# RCA-78-22-010-1: Adjust and Repair Cowl Harness

<b>Document Type</b>	Customer Satisfaction Campaign Bulletin
<b>Date</b>	July 22, 2022
<b>Affected Region(s)</b>	USA
<b>Affected Model(s)</b>	R1T
<b>Model Year(s)</b>	2022
<b>Approximate Build Dates</b>	August 2021 - March 2022
 Refer to the FSA Dashboard to determine if this document applies to a specific vehicle.	
<b>Vehicle System</b>	78 - Low Voltage Electrical
<b>Minimum Service Location</b>	Service Center

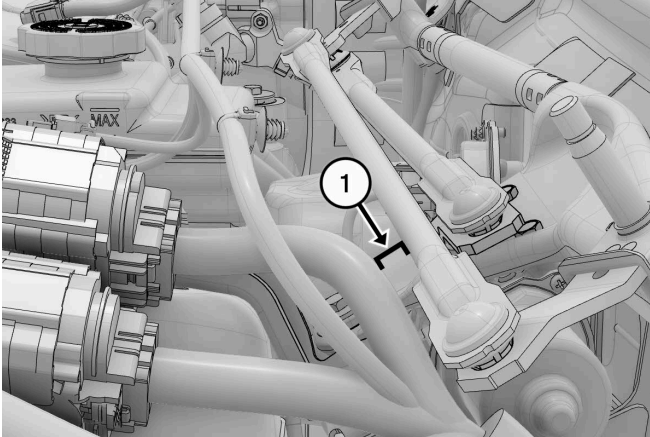
1. Remove: Screen, Leaf (refer to service manual procedure 647920010).
2. Check the minimum distance between the wiper linkage and the harness.

- If the gap is 40 mm (1 9/16 inches) or greater, no additional work is required. Reinstall all components that were removed for access and replace all non-reusable components.
- If the gap is less than 40 mm (1 9/16 inches), continue to the next step.

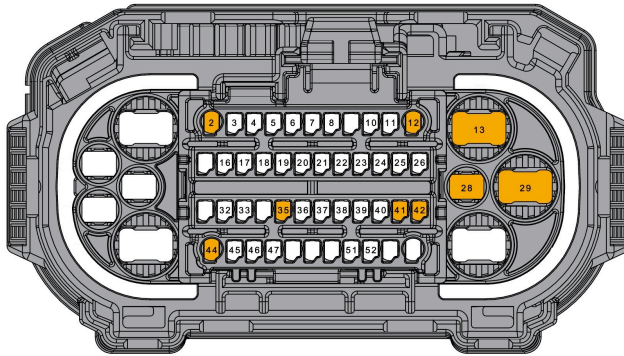
3. Inspect the wires in the highlighted area:

- If abrasion has damaged the wiring insulation:
  - If any of the following wires are affected, replace the harness. Escalate for diagnostic assistance. Make sure that the grommet is positioned correctly, as described in the [Reposition Grommet](#) section and that the harness is properly secured to the bracket, as described in the [Secure Harnesses to Bracket](#) section.

- Repair any other damaged wires. Escalate for diagnostic assistance. Continue to the [Reposition Grommet](#) section.
- If the protective tape has abraded and exposed wiring insulation, but the wiring insulation is not damaged, rewrap the affected area with new protective tape. Continue to the [Reposition Grommet](#) section.
- If the wiring and tape are undamaged, continue to the [Reposition Grommet](#) section.

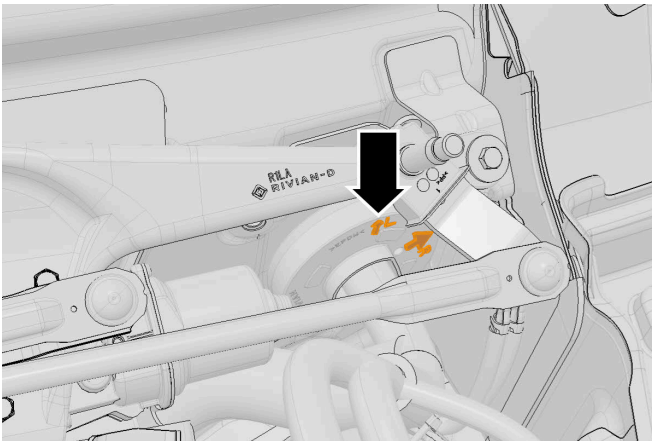
2. Inspect the position of the grommet:

- If the small arrow next to the "L" points upward, skip to the [Secure Harnesses to Bracket](#) section.
- If the small arrow next to the "L" points in a different direction, continue to the next step.

3. Rotate the grommet so that the small arrow next to the "L" points upward.

4. Fully reseat the grommet.
5. Continue to the [Secure Harnesses to Bracket](#) section.

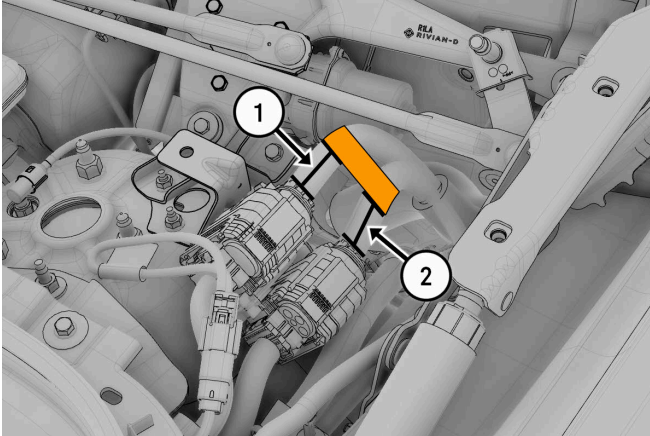
1. Apply tape.

1	60 mm (2 3/8 inches)
2	50 mm (2 inches)

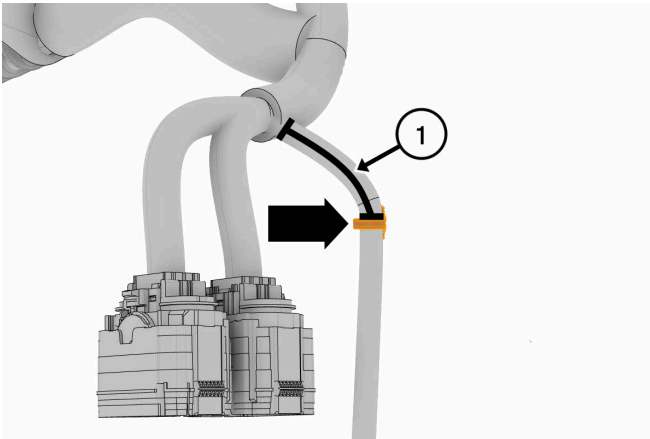
2. Install:

1	60 mm (2 3/8 inches)
---	----------------------

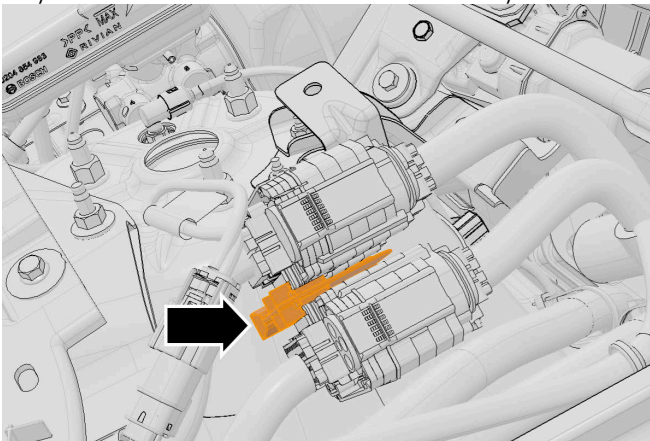
4. Make sure that both harnesses are secured to the highlighted component. Make sure the component is fully secured to the studs on the vehicle body.

5. Turn on the windshield wipers. Make sure that the wiper arm does not contact the harness. If necessary, push the harness downward to avoid potential contact.
